順利塑膠五金製品廠
 Shun Li Plastic Metal Manufactory
 DRAWN BY: Sunny-Lee
 REVIEWED BY: Andy-Chen
 CHECKED BY: Joe-Lee
 APPROVED BY: Joe-Lee

VIEW: UNIT: mm SCALE: 1:1
 PART NAME: PHONE JACK DATE: 2010.11.22 REV: D
 MODEL NO: EJ-3674-GP DRAWING NO:

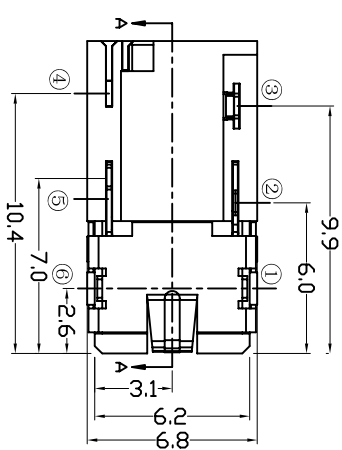
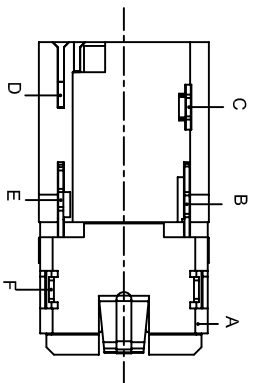
注：
1.增加接觸量尺寸，版本變為B
2.磷銅C5191變更為磷銅C5210;版本變為C
3.產品導入無齒，Housing材料更換為HTNFR52G30(Dupont),D/C由年月日變更
為年+周，版本變為D.
